NUMBER: 25-003-16

GROUP: Emissions Control

Replace Vehicle Emission Certification Information Label

Fig. 1 Missing Info On VECI Label

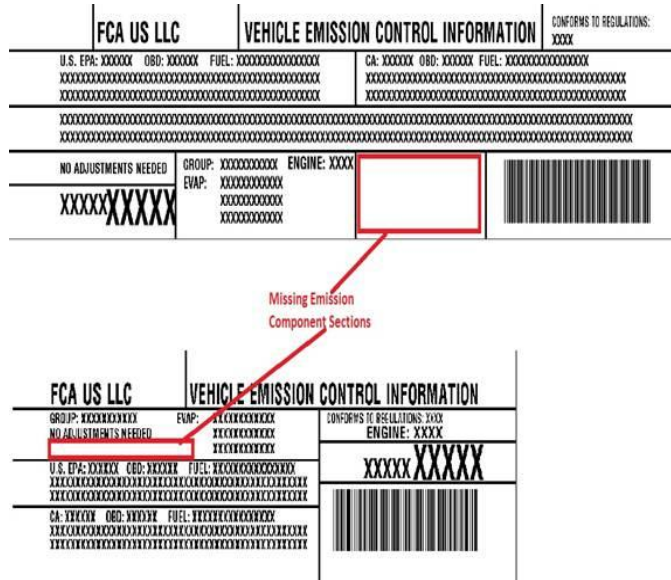
The customer may notice that some info is missing on their VECI labels.

NOTE: Only replace the VECI label if the information shown in (Fig. 1) is missing. If information is shown in this area, do not replace the label.

1. Remove the old VECI label.
2. Remove residue or dirt from label location on the vehicle using isopropyl alcohol or equivalent.
3. Install new VECI label where the old VECI label was ensuring that the label is free of air bubbles and wrinkles and the entire label is adhered to the surface.
